Rail Coach Factory, Kapurthala

Sub: Retro-fitment of 110V, 120Ah Battery in existing LVPH Coaches.

CAI NO.: ED/CAI/043 dated: 02.06.2025

**COACH ALTERATION INSTRUCTION
FOR RETRO-FITMENT OF 120AH, 110VDC VRLA
BATTERY BANK IN PLACE OF
EXISTING 70AH, 110VDC VRLA BATTERY BANK
IN LVPH COACHES**

DY.CEE/D&D

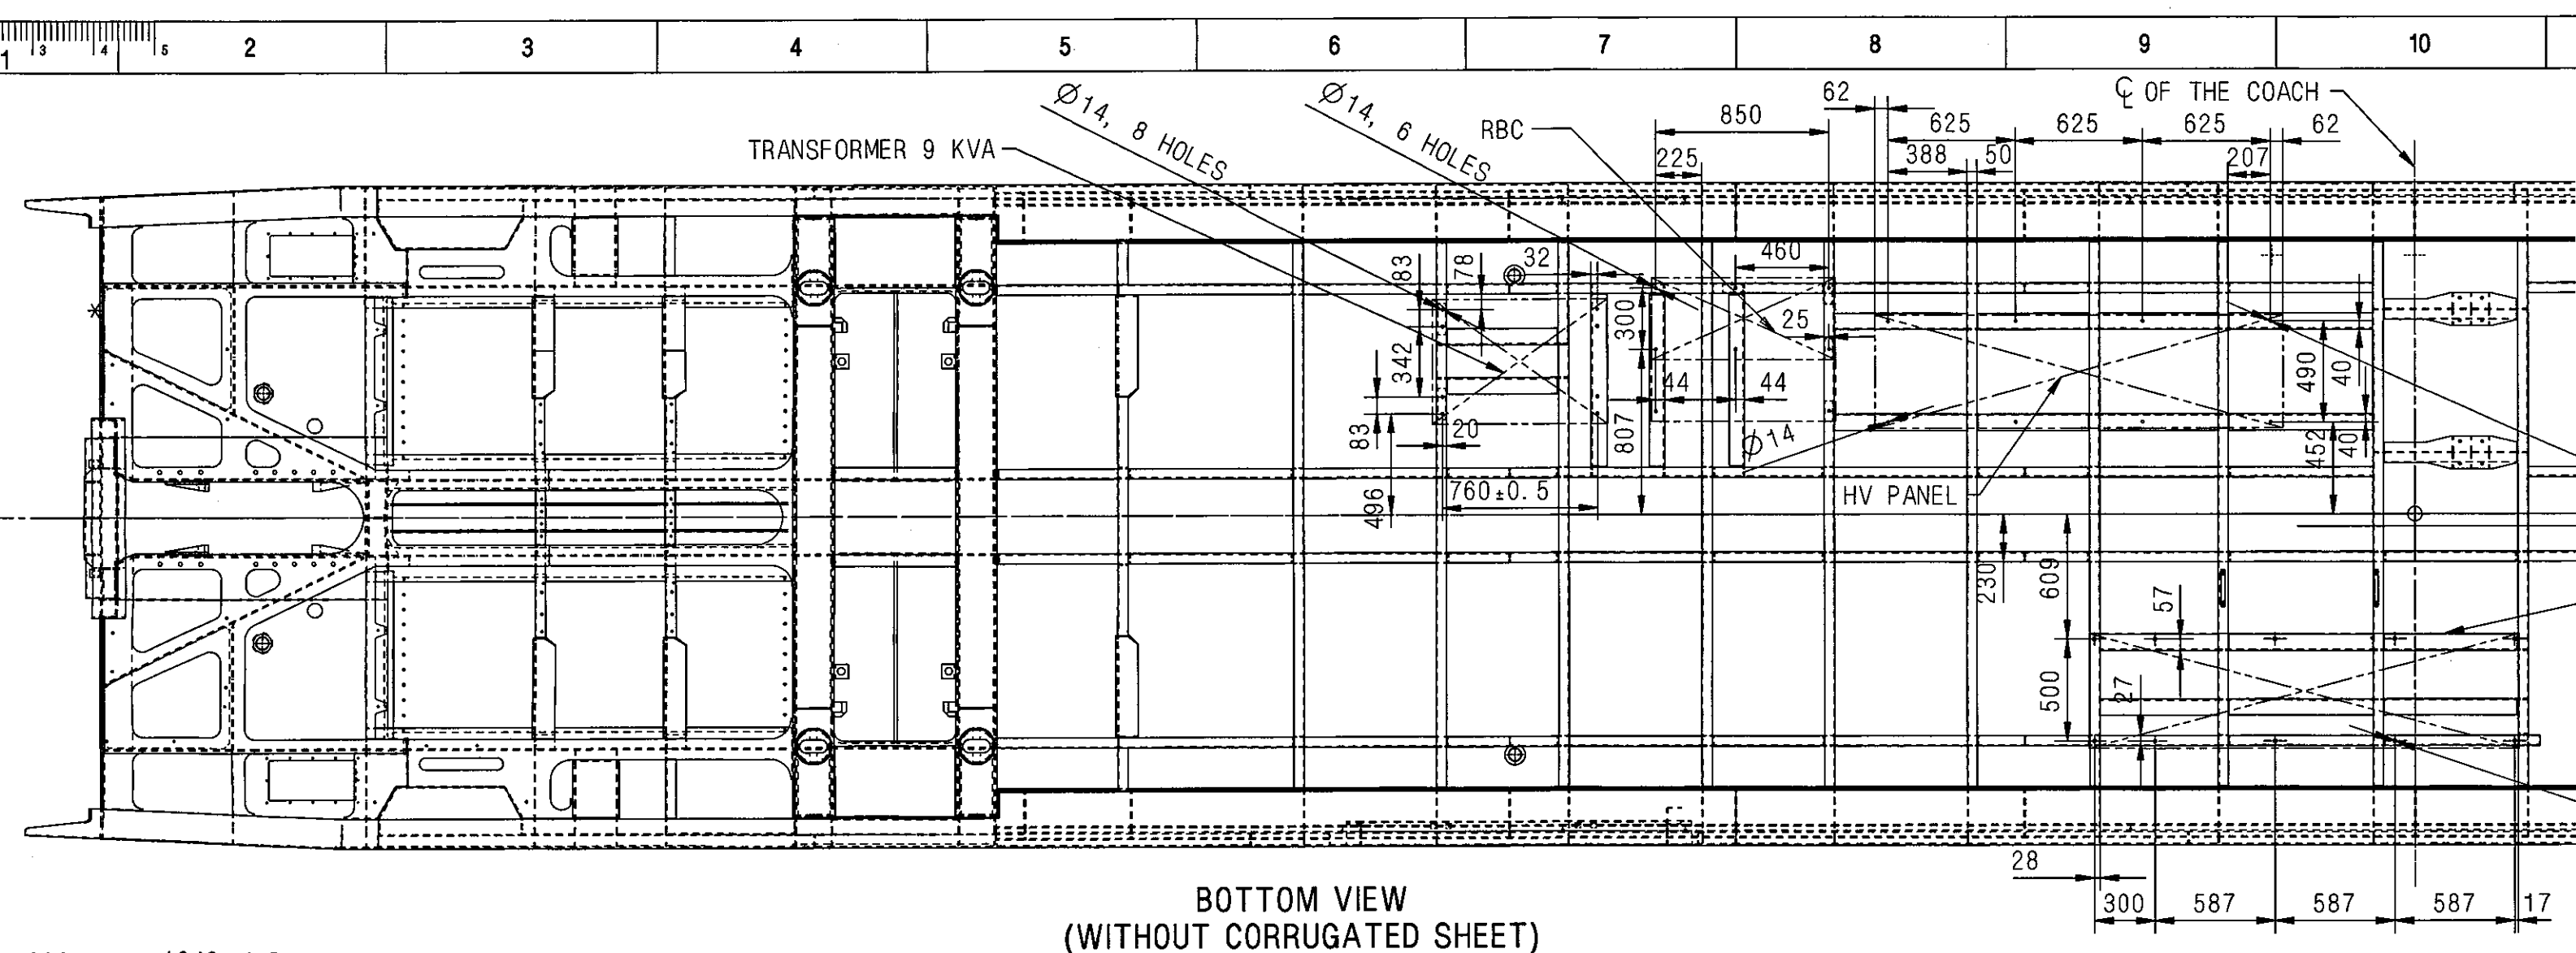
- Removal of +VE & -VE fuse from respective Battery Fuse Boxes.
- Disconnection of mains +VE & -VE cables (10 sqmm) from battery monoblocks. (Ref. Harness Route no. 35 & 39, RCF Drg. No. VP70019, alt 'b')

- C. Loading of fully charged 120AH, 110VDC VRLA battery set alongwith tray arrangement.
- D. Interconnection cell connections & provision of Battery terminal caps (As per Recommendations of Battery OEM).
- E. Connection work of battery bank (refer RCF Drg. No. VP70019, alt 'b'). Precaution shall be taken to avoid any short circuit of +VE & -VE battery terminals.
- F. Re-insertion of battery fuse inside Battery fuse boxes.

PL NO. NIL
DRG.NO. VP11119

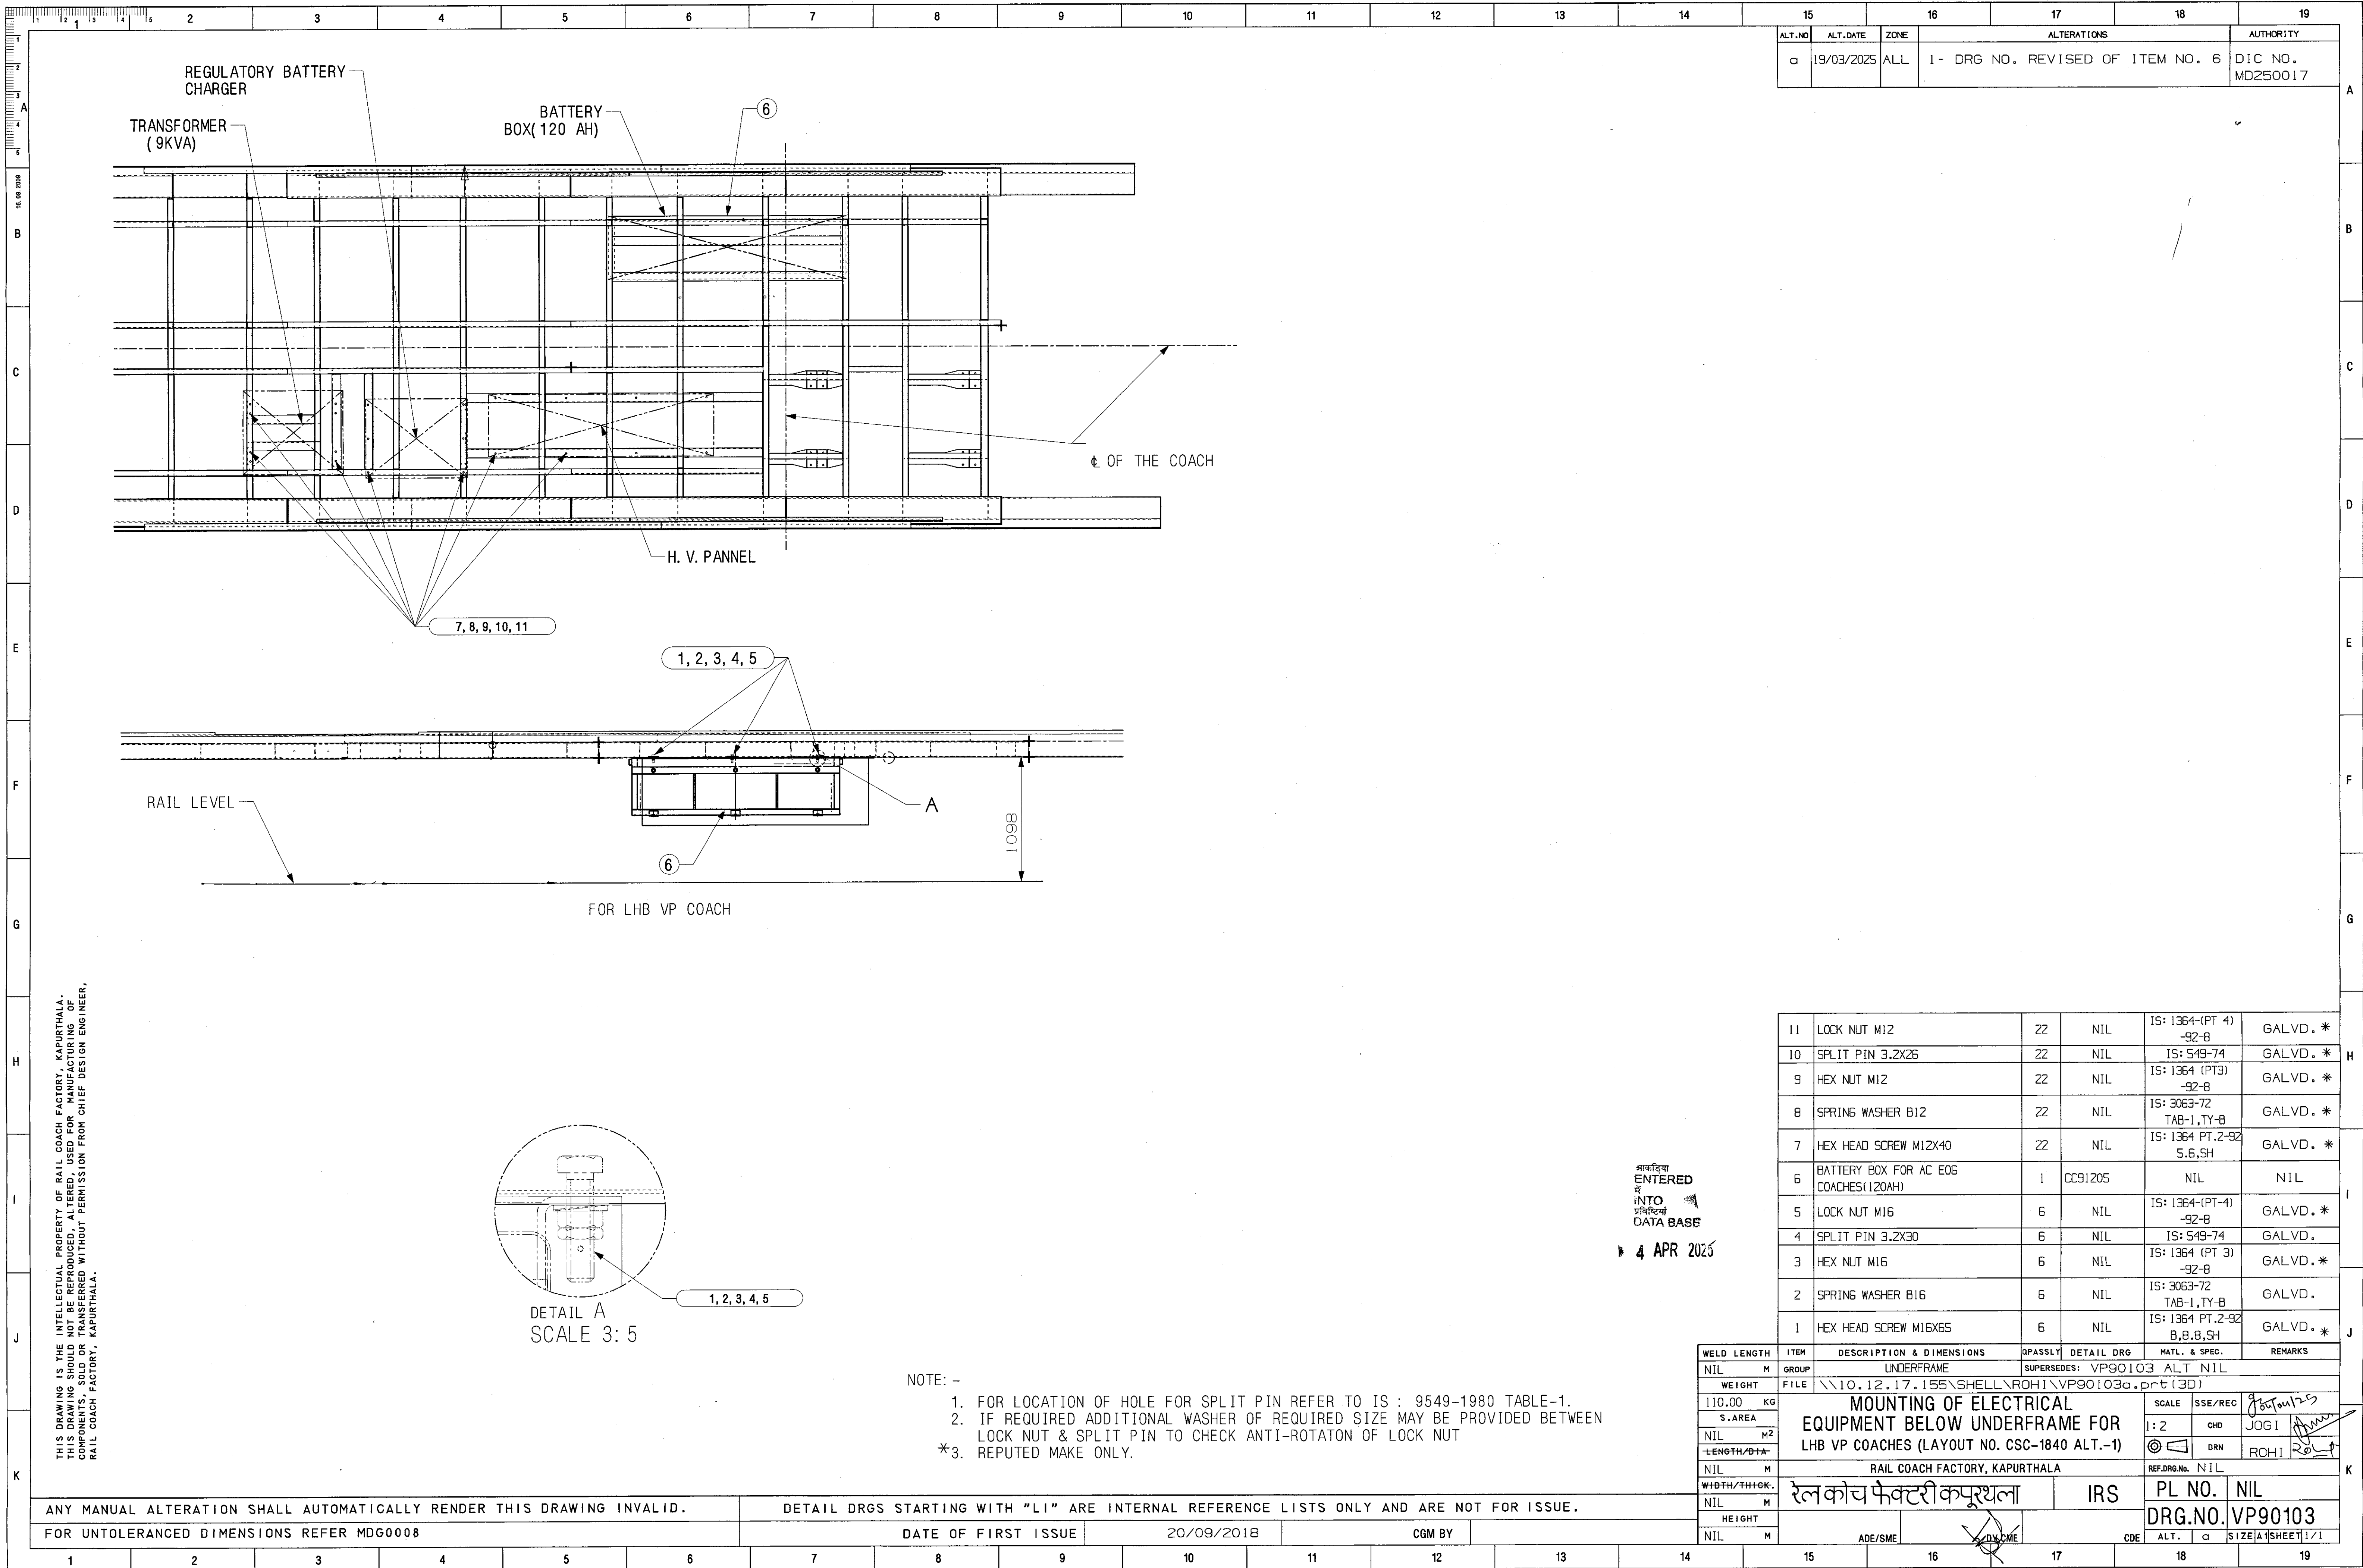
- Modification in mounting holes shall be done for provision of 120AH battery box as per “Under frame complete for LHB high capacity parcel van coaches” to RCF Drg. No. VP11119, Alt ‘g’. Holes shall be jig drilled by making use of template (as per above mentioned drawing) for battery box mounting holes. Holes by welding process are not permitted.
